Northern Fashion (Extension)

Plot 16-18 Dakkin Panishail, EPZ kaliakur road, Kashimpur, Gazipur, Dhaka
(23.991820, 90.257763)

27 November 2023

Observation-01: Mismatch in as-built drawings. (Building-D: New Warehouse)

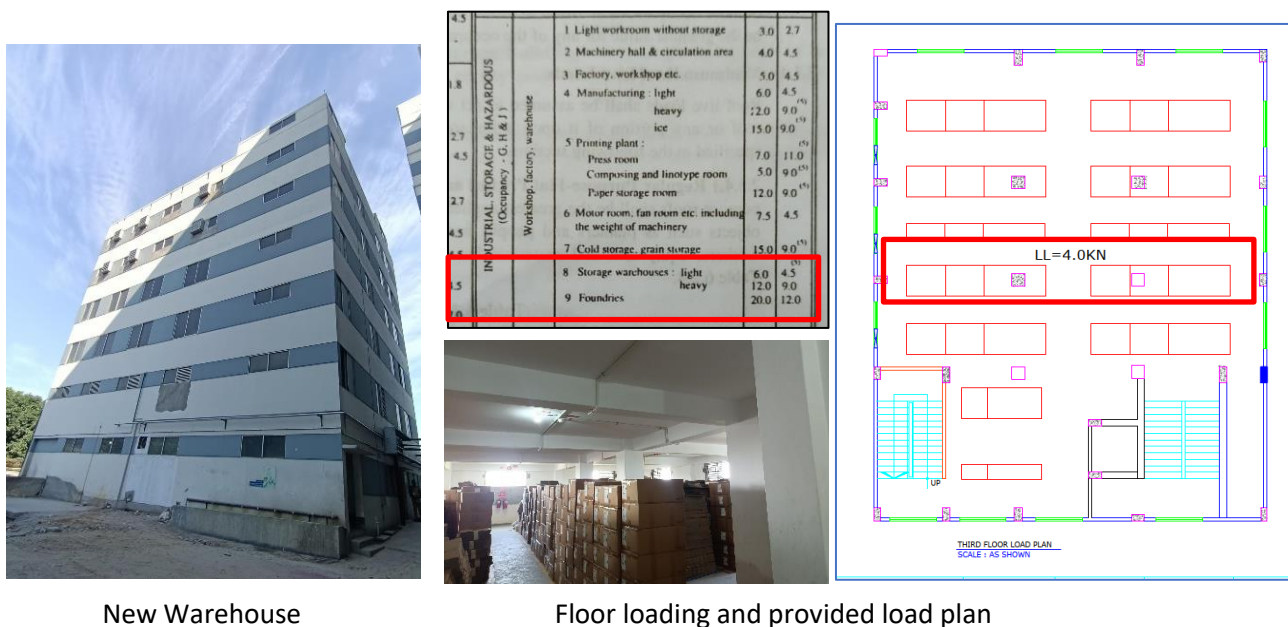
Description: During inspection, number of rebar at C3 type column not matched. 3 nos of rebars were found at short face instead of 4 nos. Moreover, in the sectional elevation basement floor has not been shown. Building engineer is required to update as-built drawing incorporating all the mismatches.
